**Management Officer Report
Committee Application**

Summary	
Committee Meeting Date: 13 October 2020	
Application ID: LA04/2020/0761/F	
Proposal: Demolition of existing buildings and erection of 10 storey mixed use development comprising a cafe on the ground floor and 85no. serviced apartments for both short and long term occupancy on the floors above.	Location: 57-59 & 61-63 Dublin Road Belfast BT2 7HE
Referral Route: Major Application	
Recommendation:	Approval subject to conditions and a Section 76 Agreement.
Applicant Name and Address: John Smyth's Estates Ltd 192a Church Road Holywood BT18 9RN	Agent Name and Address: O'Toole & Starkey Ltd Arthur House 41 Arthur Street Belfast BT1 4GB
<p>Executive Summary:</p> <p>Planning permission is sought for the erection of a ten storey building comprising a café and ancillary uses on the ground floor and 85 serviced apartments above for both short and long term occupancy. The site is located within Belfast City Centre between the Dublin Road and Ventry Street. The proposal incorporates a roof top terrace, a gym and balconies providing satisfactory amenity provision. A two storey building is currently located on the site. Planning permissi

Dublin Road Elevation

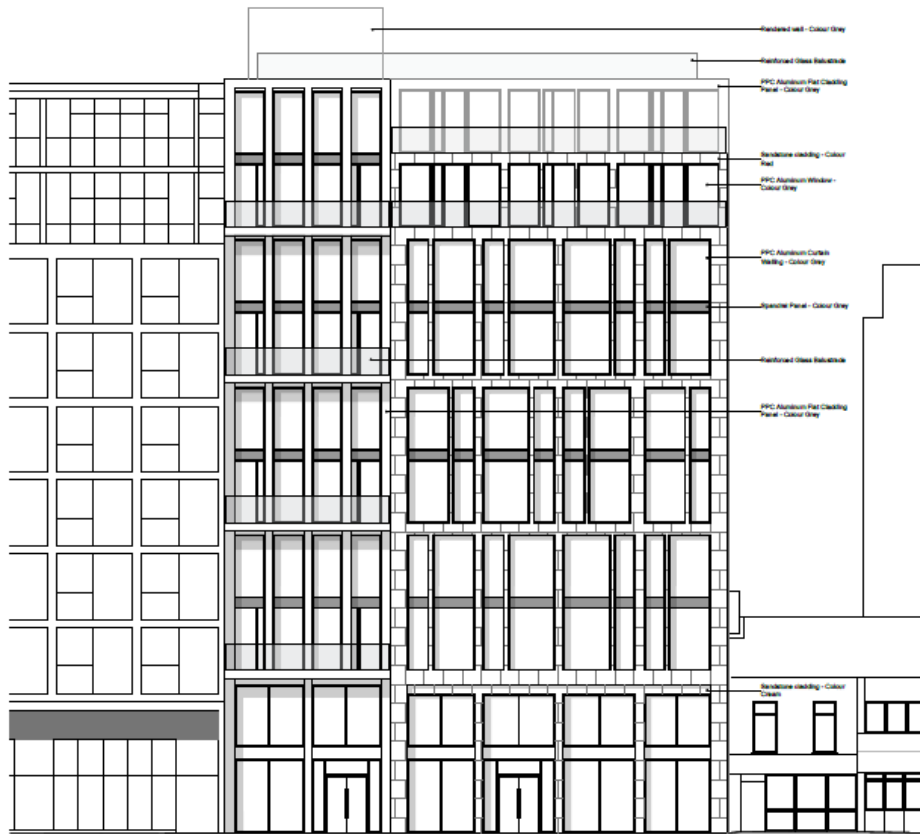
3.10.4	In design terms the front elevation onto Dublin Road comprises two distinct elements. The first is a narrow link section (6.3m wide) adjacent but marginally setback from the 'Gallery' and a wider (14.9m wide) primary building façade which sits forward from the link element and incorporates an 8 storey frame to shoulder height with an additional two setback upper floors above.

3.10.5	The adjacent Gallery development incorporates a seventh floor shoulder height with two setback floors above. The uniform shoulder height of the wider section of the proposed development at eighth floor level (25.2m) generally accords with and continues the seventh floor shoulder height already established by the Gallery (24.3m). The two upper floors of the wider section of the proposed development are setback from the front elevation by 1.25m and 1.0m respectively. The setback helps to visually connect the shoulder heights of both buildings along this stretch of Dublin Road, whilst affording a degree of sub-ordinance to the upper two floors.

3.10.7	The link (narrow) section on the Dublin Road elevation extends on a uniform vertical plane to the upper 10 storey height (31.5m) and sits behind the main facades of the wider section and the Gallery on either side. This element of the building is proposed to be finished primarily in grey aluminium cladding. The link section provides visual interest and variation in the Dublin Road elevation a view supported by the Urban Design officer who noted that 'whilst creating a modest variance in the roofline and represents a welcomed break in what could have been a very uniform volumetric form when viewed in conjunction with its neighbour'

3.10.9	The wider section of the Dublin Road elevation incorporates a double height (6.7m) base finished in curtain glazing within which the café will be accommodated on the ground floor and apartments at first floor level. This wider part of the building is proposed to be finished primarily in red sandstone cladding. The Urban Design officer has commented that 'The double height base places a vertical emphasis on this component and its articulation with a red sandstone frame/surround, which protrudes beyond the curtain walling helps the building to confidently ground at street level'.

3.10.10	<p>A vertical emphasis is continued above the base to the shoulder height at the 8th floor with floors grouped in bands of two. The primary finish proposed within the wider section is red sandstone cladding which picks up on the red brick in surrounding buildings. The design of the Dublin Road elevation includes the use of horizontal and vertical banding with generous reveals defining double height window openings. The double height floor arrangement is also proposed in the link section which incorporates balconies at alternate floor levels. The top two floors are setback from the Dublin Road. The top floor is to be finished in aluminium grey cladding panels which is also proposed on the link element.</p>

Dublin Road Contextual Elevation

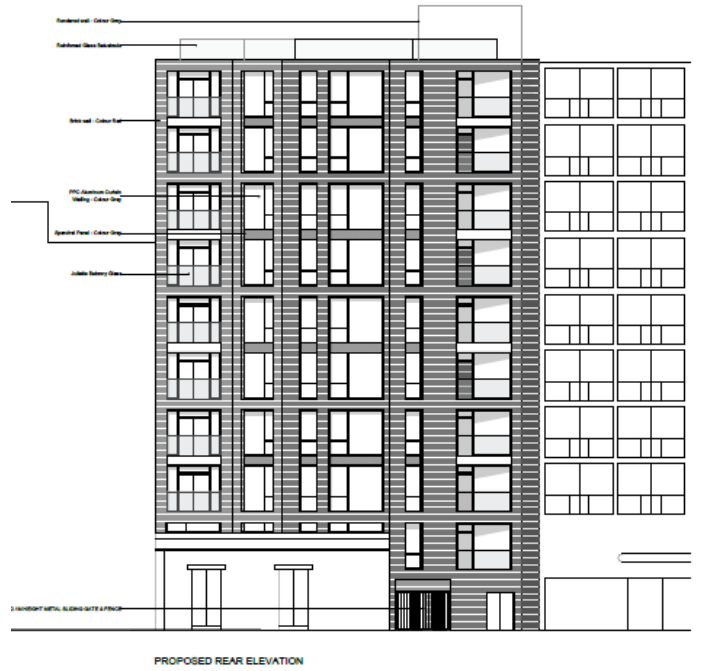
3.10.6	A stair core/lift overrun extends 2.6m above roof level and is setback 12.m from the Dublin Road elevation ensuring views will be limited. The upper height of the proposed development (31.5m) generally accords with the upper height of the Gallery at 30.8m.
